Project	IEEE 802.16 Broadband Wireless Access Working Group < http://ieee802.org/16 >
Title	Stuff, the sequel
Date Submitted	2002-10-15
Source(s)	Nico van Waes Nokia Wireless Routers
Re:	IEEE LMSC Sponsor Ballot recirculation of P802.16a/D5
Abstract	Proposed material referenced by submitted comments. All changes compared to r1 are indicated in green.
Purpose	Adoption
Notice	This document has been prepared to assist IEEE 802.16. It is offered as a basis for discussion and is not binding on the contributing individual(s) or organization(s). The material in this document is subject to change in form and content after further study. The contributor(s) reserve(s) the right to add, amend or withdraw material contained herein.
Release	The contributor grants a free, irrevocable license to the IEEE to incorporate material contained in this contribution, and any modifications thereof, in the creation of an IEEE Standards publication; to copyright in the IEEE's name any IEEE Standards publication even though it may include portions of this contribution; and at the IEEE's sole discretion to permit others to reproduce in whole or in part the resulting IEEE Standards publication. The contributor

Figure 128ax—Time Plan - One TDD time frame

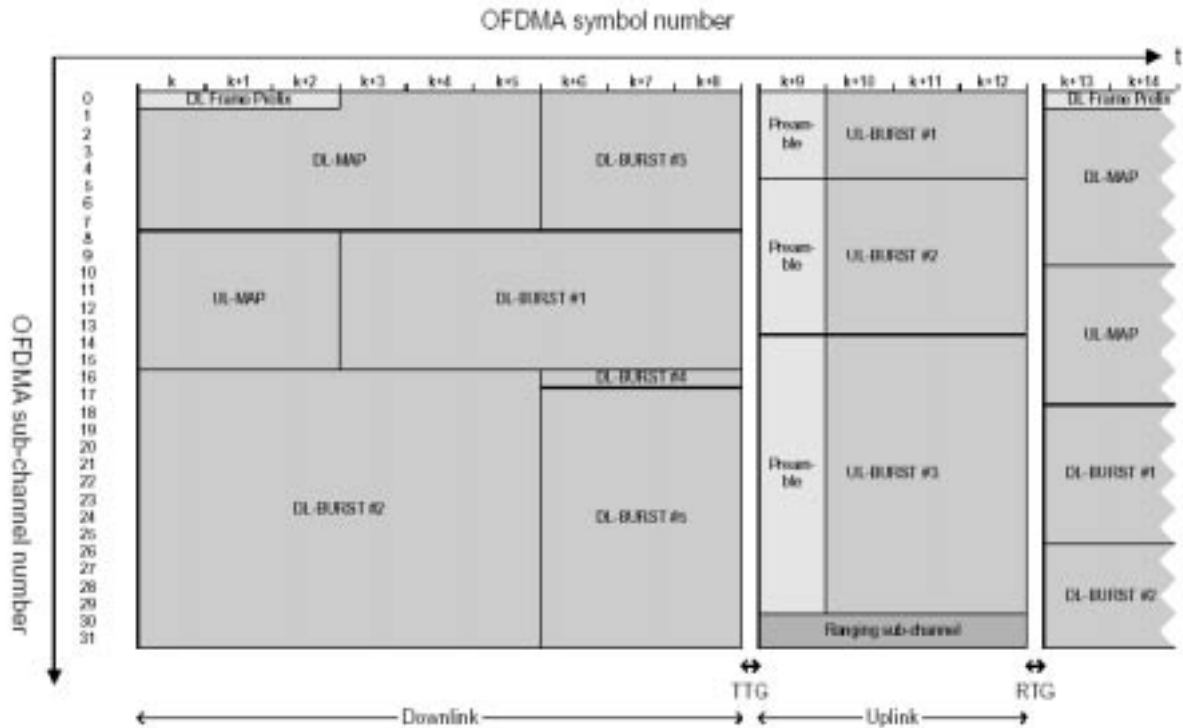
Replace Figure 128ax with:
